Airworthiness Directives; Agusta S.p.A. Model A109E Helicopters

ACTION: Notice of proposed rulemaking (NPRM).

Agusta S.p.A: Docket No. 2001-SW-09-AD.

Airworthiness Directives; Robinson Helicopter Company Model R44 Helicopters

Figure 1

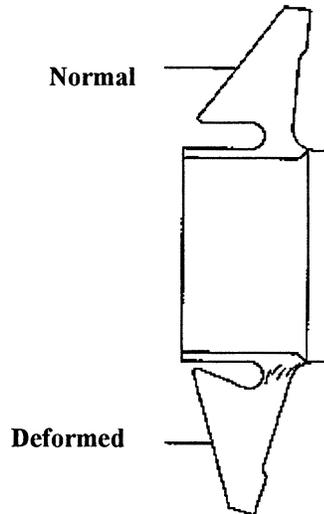
(b) Before each engine start, check the indicator for damage in accordance with Figure 1 of this AD. If damage is found, before further flight, replace the damaged indicator with an airworthy indicator, and replace the tail rotor yoke, P/N 406-012-102-107, with an airworthy tail rotor yoke.
